Access Compliance Report

Public Rights-of-Way (Curb Ramps)

Intersection ID: 52630	Main Street: WEYMOUTH_LN	Cross Street: ALEXANDER_DOWD_DR	Location: NW
ADA ID: EB35A54978B6	Ramp Type: Perp	Initial Pass/Fail: Fail	Overall Compliance: No
		Severity Score: 12.5

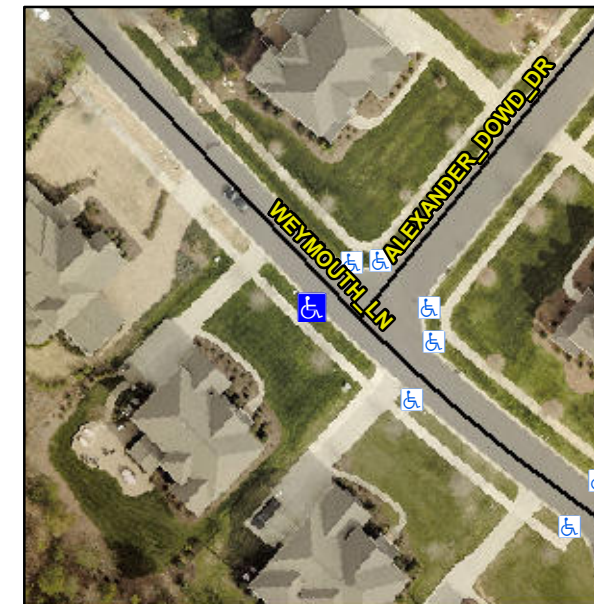
Not Found, R304.5.3

Compliance	Description	Data	Compliance	Description	Data
N/A	Ramp Length (in)	96.0	Yes	Ramp Slope (%)	6.7
Yes	Ramp Width (in)	60.0	No	Ramp XSlope (%)	5.3
N/A	Flare Type LT	N/A	N/A	Flare Type RT	N/A
N/A	Flare Slope LT (%)	N/A	N/A	Flare Slope RT (%)	N/A
N/A	Flare Traversable LT?	N/A	N/A	Flare Traversable RT?	N/A
N/A	Landing Length (in)	N/A	N/A	DWS Provided?	N/A
N/A	Landing Width (in)	N/A	N/A	DWS Contrast?	N/A
N/A	Landing Slope (%)	N/A	N/A	DWS Length (in)	N/A
N/A	Landing X Slope (%)	N/A	N/A	DWS Full Width?	N/A
N/A	Landing Curb? (Y/N)	N/A	N/A	DWS Offset (in)	N/A
N/A	Shared Landing?	N/A			
N/A	Gutter Ponding?	N/A	N/A	Gutter Slope (%)	N/A
N/A	Gutter Lip Ht (in)	N/A	N/A	Gutter X Slope (%)	N/A
N/A	Painted X Walk1?	No	N/A	Painted X Walk2?	N/A
	X Walk 1 Direction	To NE		X Walk 2 Direction	N/A
N/A	X Walk 1 Width (in)	N/A	N/A	X Walk 2 Width (in)	N/A
	X Walk 1 Slope (%)	1.7		X Walk 2 Slope (%)	N/A
	X Walk 1 X Slope (%)	3.4		X Walk 2 X Slope (%)	N/A

Remove & Replace Entire Ramp.
